# PERMIT

## SEWAGE DISPOSAL SYSTEM

SUBDIVISION Triadelphia Woods LOT 41 ROAD 12621 Fawn Run Court

<b>CLARK • FINEFROCK &amp; SACKETT, INC.</b> ENGINEERS • PLANNERS • SURVEYORS 7135 MINSTREL WAY • COLUMBIA, MD 21045 • (410) 881-7500 BALTO. • (301) 621-8100 - WASH		SCALE	1"=50'	
		DRAWING	1 OF 1	
DESIGNED	J.M.E.	<b>SITE DEVELOPMENT PLAN</b> <b>LOT 41</b> <b>TRIADELPHIA WOODS</b> SECTION 1 AREA 2 3 <sup>RD</sup> ELECTION DISTRICT HOWARD COUNTY MARYLAND	JOB NO.	93-108
DRAWN	C.A.F.		FILE NO.	93-108X
CHECKED	J.M.E.		FOR: WILLIAMSBURG BUILDERS P.O. Box 1018 Columbia, Md 21044	
DATE	Oct 1993

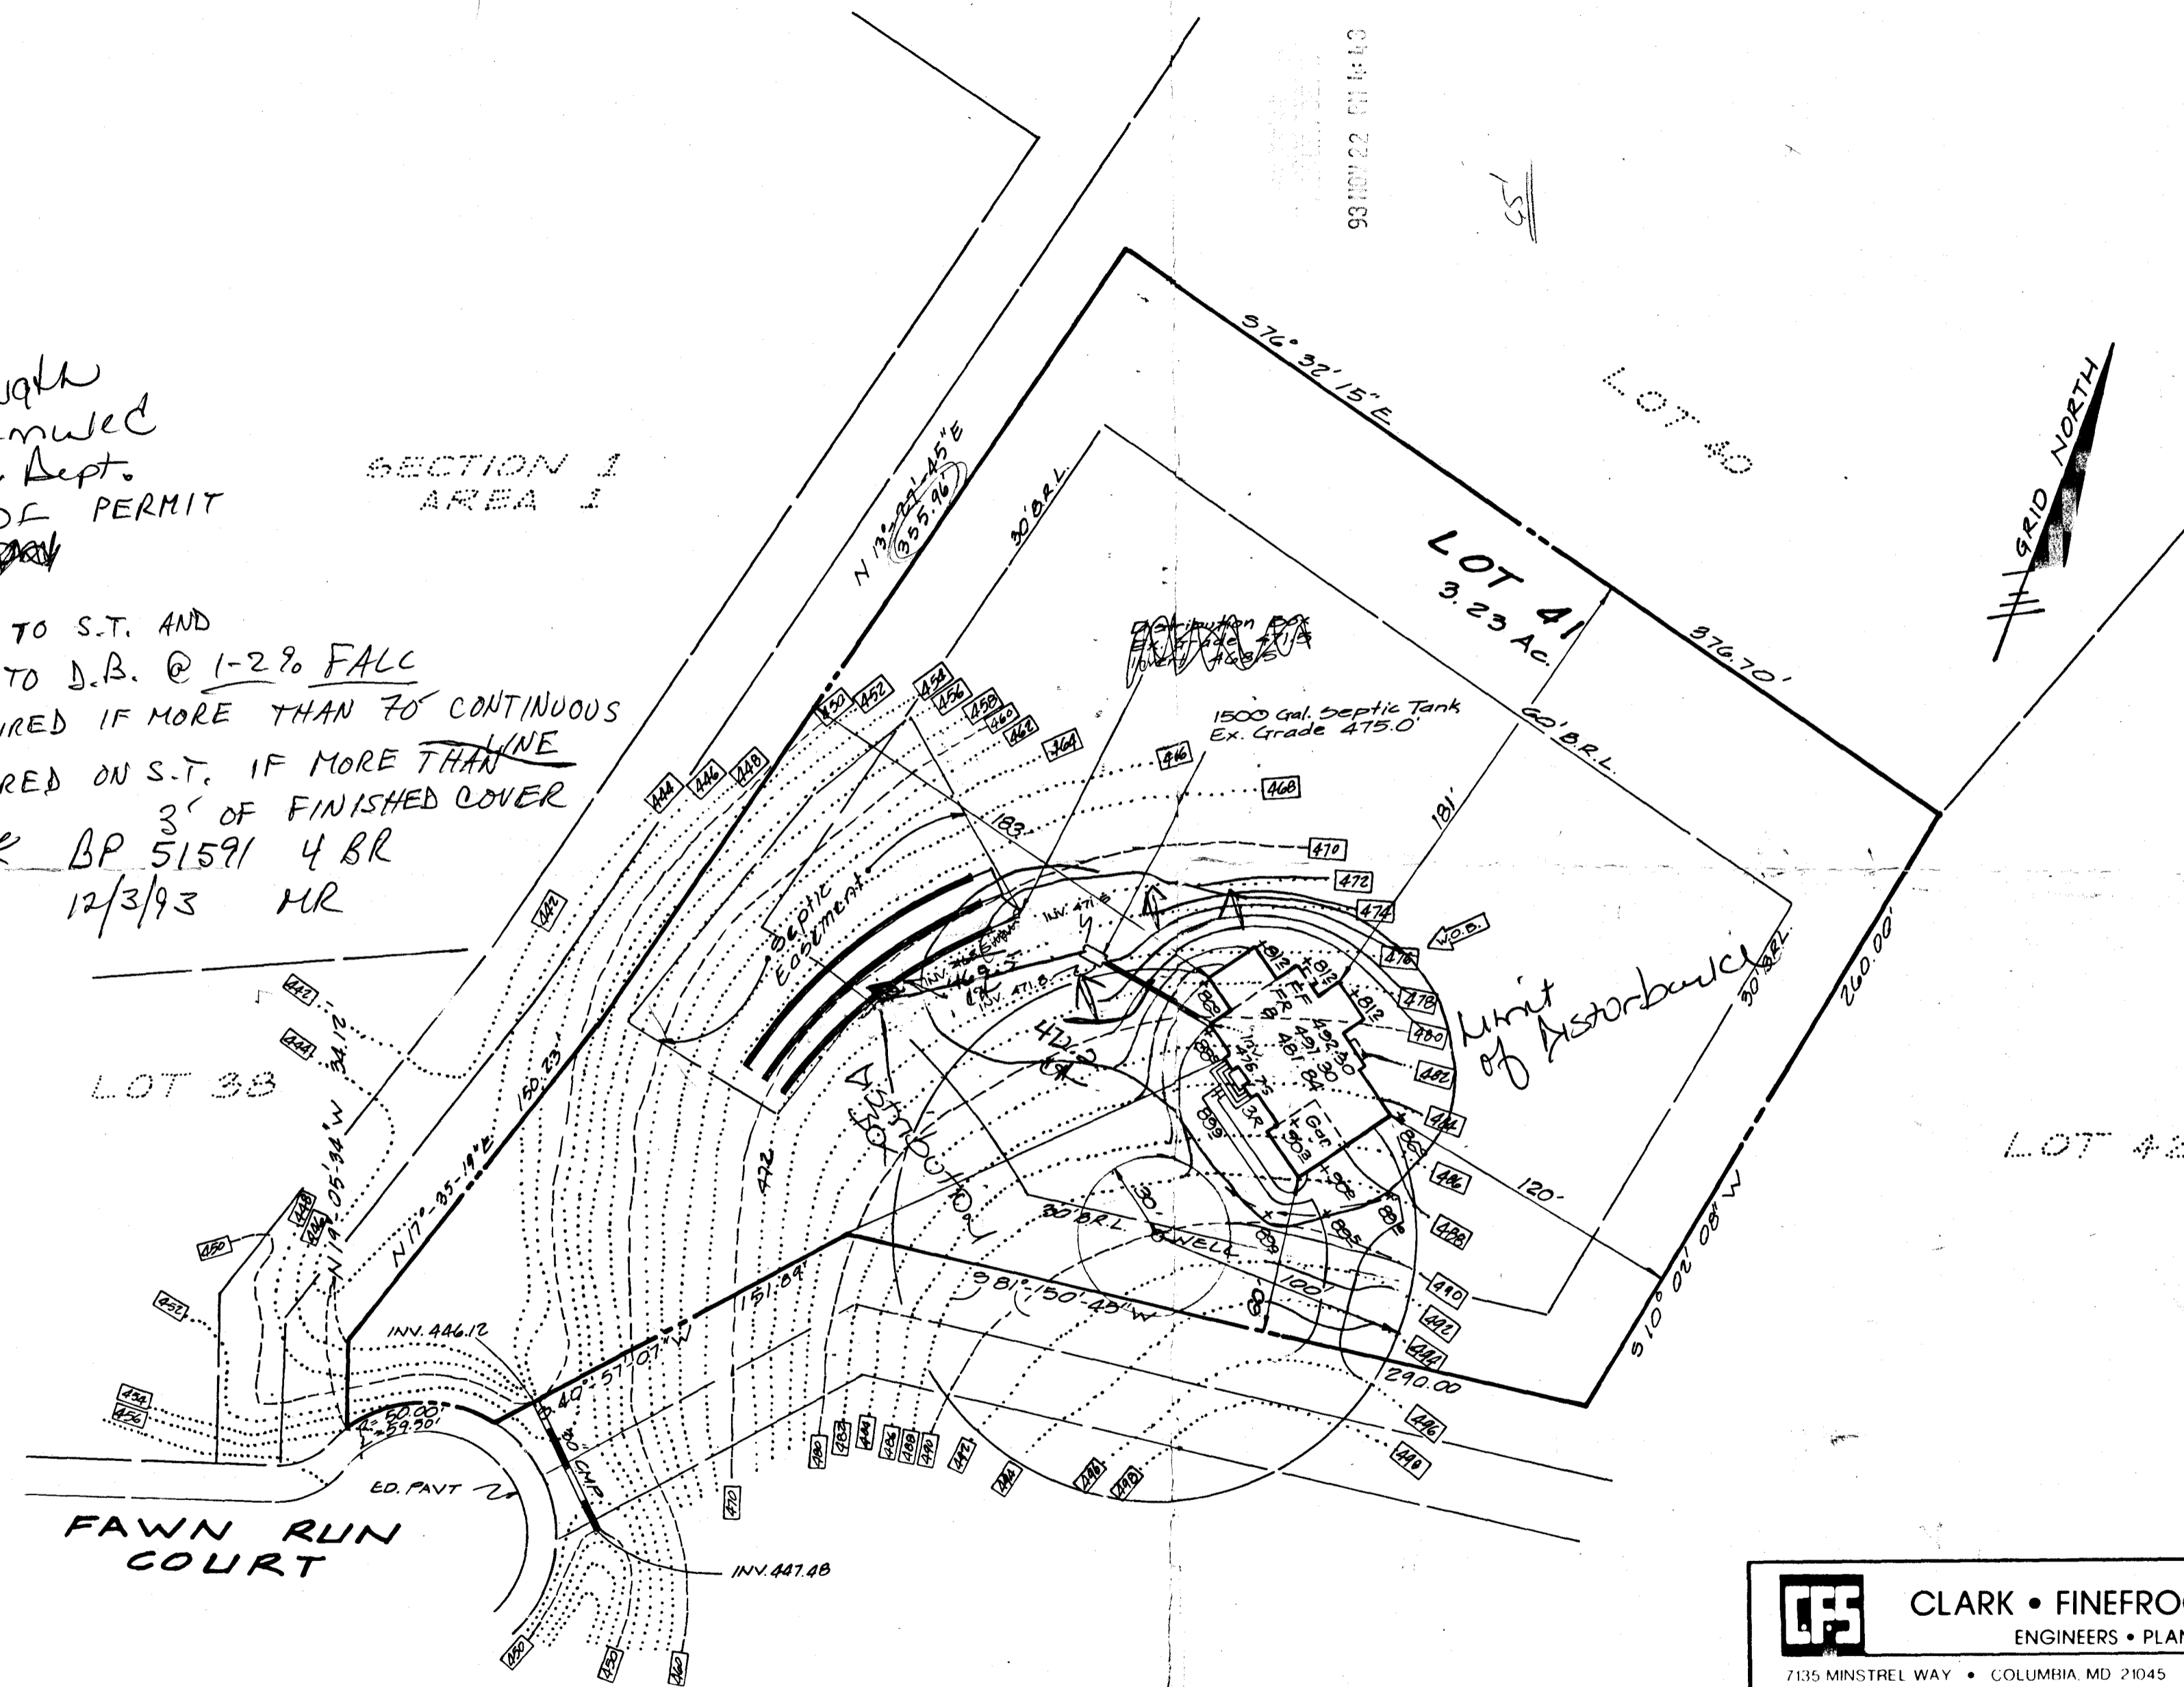
10' LINE PRIOR TO S.T. AND  
10' LINE PRIOR TO D.B. @ 1-2% FALL  
CLEANOUT REQUIRED IF MORE THAN 70' CONTINUOUS  
MANHOLE REQUIRED ON S.T. IF MORE THAN  
3' OF FINISHED COVER  
elevations OK BP 51591 4 BR  
12/3/93 MR
